PASADENA WATER & POWER GLENARM REPOWERING PROJECT

CONDITIONAL USE PERMIT No. 5804

FINAL
ENVIRONMENTAL
IMPACT REPORT

Alternative 3A Site Plan

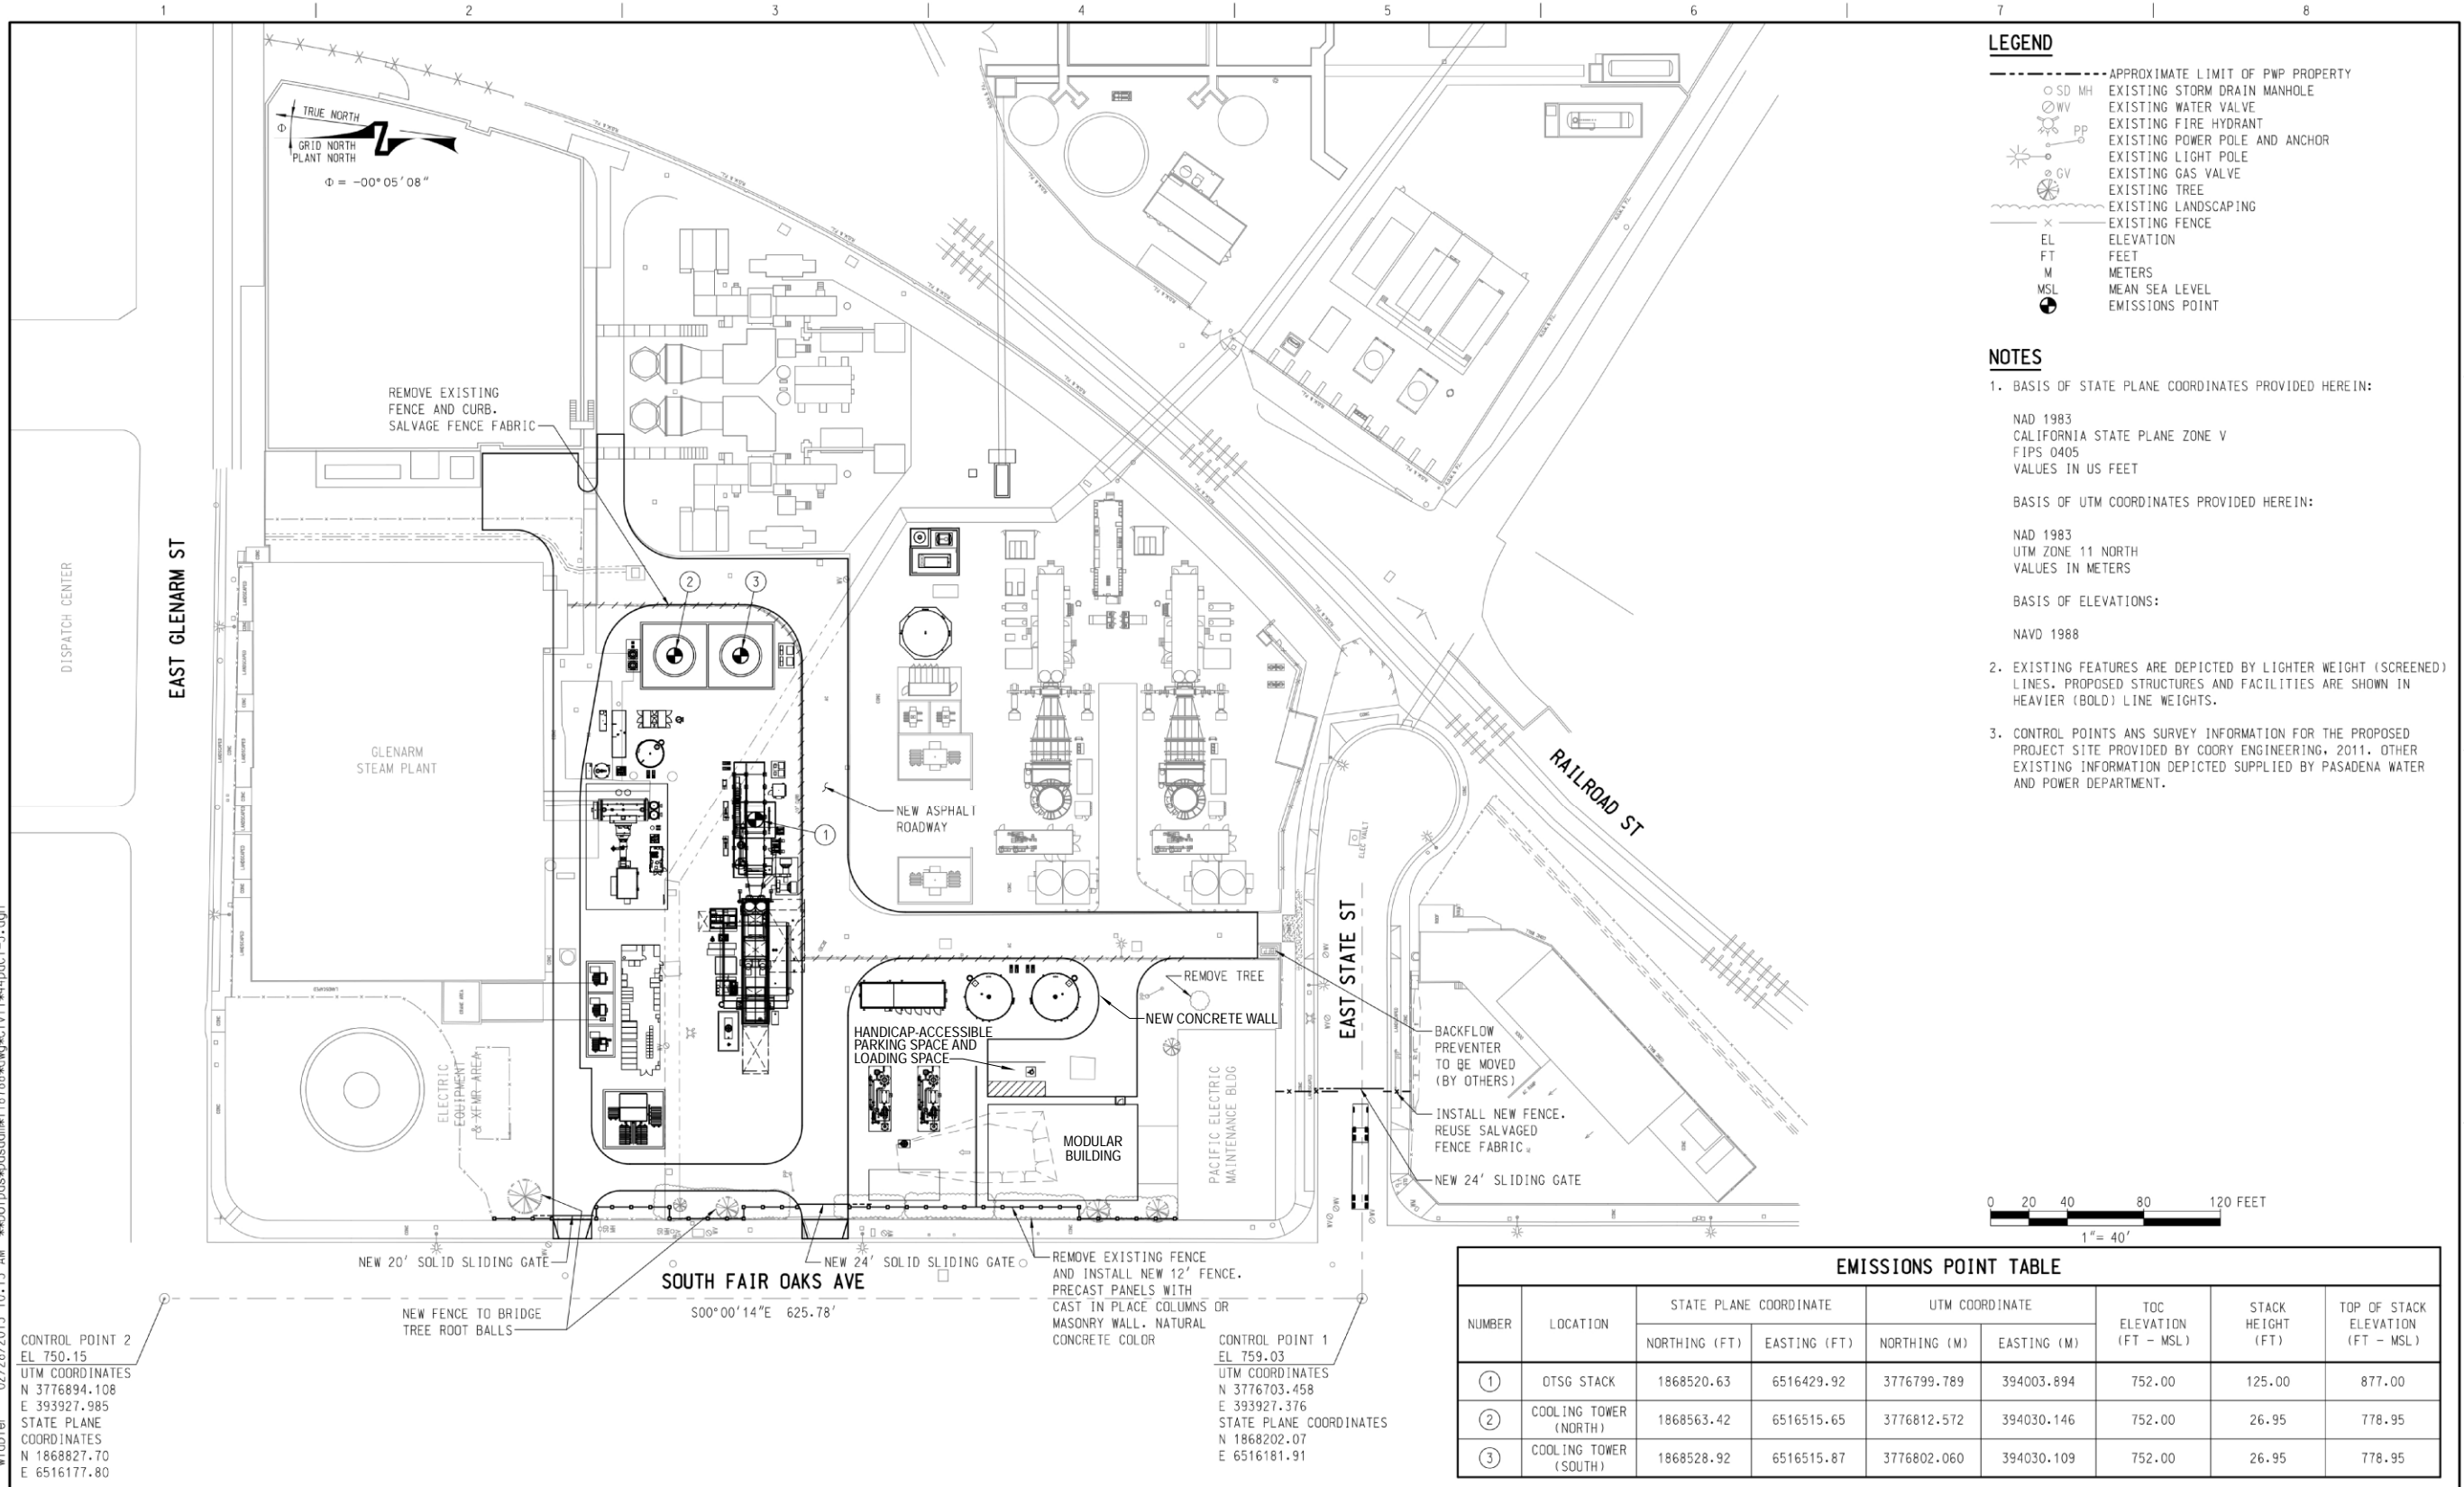
The ballooning cost of hazardous materials [specifically asbestos-containing materials (ACMs)] abatement and structural work within the Glenarm Building has prompted the Pasadena Department of Water & Power to more closely consider the consolidation of control room support elsewhere on the plant site. This Topical Response therefore presents a variation on Alternative 3 in **Section 5.0, Alternatives**, of the Draft EIR, which proposes a temporary modular building to house new consolidated control room facilities, in the event that reuse of the Glenarm Building ultimately proves economically infeasible. This variation on Alternative 3 (“Alternative 3A”) also proposes landscape enhancements and minor changes in the location of future parking, in response to public and Planning Commission comments received on the Draft EIR.

Under Alternative 3A, a modular building housing a control room supporting the new Unit GT-5 and existing gas turbine power generation units would be installed near the western perimeter of the Glenarm Plant, north of the Pacific Electric Railway Company (PERC) substation building and fronting on Fair Oaks Avenue. The building would be up to 50 feet width and 77 feet in length, or approximately 3,850 square feet, and up to 15 feet in height, and would occupy a portion of the area proposed for employee parking under the original project. The modular building would be set back from Fair Oaks behind an approximately five- to eight-foot-wide setback and separated from the PERC building on the south by a 21-foot buffer area. The building would be clad with metal siding to enhance its appearance, although the final building design and materials have not yet been determined. One handicap-accessible parking space and one loading space would be provided immediately east of the building and would be accessed from a driveway off the State Street cul-de-sac. Siting of the modular building may require removal of two existing red flowering gum trees (*Corymbia ficifolia*). A new wall would be constructed along the Fair Oaks property line to screen the industrial appearance of the project site; the wall would be up to 12 feet in height, although the precise design and materials have not yet been finalized. **Figure 2-1, Alternative 3A Site Plan**, is a site plan and depicts existing buildings and equipment as well as the modular building and other built features proposed under Alternative 3A.

The site of proposed Unit GT-5 would remain unchanged compared to the project and Alternative 3 in **Section 5.0, Alternatives**, of the Draft EIR, and two equipment manufacturer configurations, GE and Rolls

The proposed modular building location was selected for visual and physical proximity to new and existing power generation units on the Glenarm Plant, while maintaining the required buffer distance from proposed Unit GT-5 structural components to be installed to the north. A new concrete wall would be erected around equipment to the north and east of the modular building. Power plant administration facilities, the Engineering Unit, and existing mechanical equipment would remain on the Broadway Plant as proposed under the Alternative 3. The State Street cul-de-sac would be closed and the existing 4,000-square-foot Pump Building on the parcel south of State Street would be remodeled and expanded to 6,000 square feet to house mechanical and maintenance shops, as proposed under Alternative 3.

The parking lot containing 45 employee and visitor parking spaces that was proposed under the original project would no longer be located along the Glenarm Plant's Fair Oaks frontage, but those spaces would instead be provided in the existing lot in the northwest corner of the Broadway Plant that is currently shared with Jacobs Engineering. Jacobs Engineering will be relocating to South Lake Avenue before project construction is complete, which will allow all parking except a limited number of handicap-accessible spaces to be moved away from Fair Oaks Avenue.
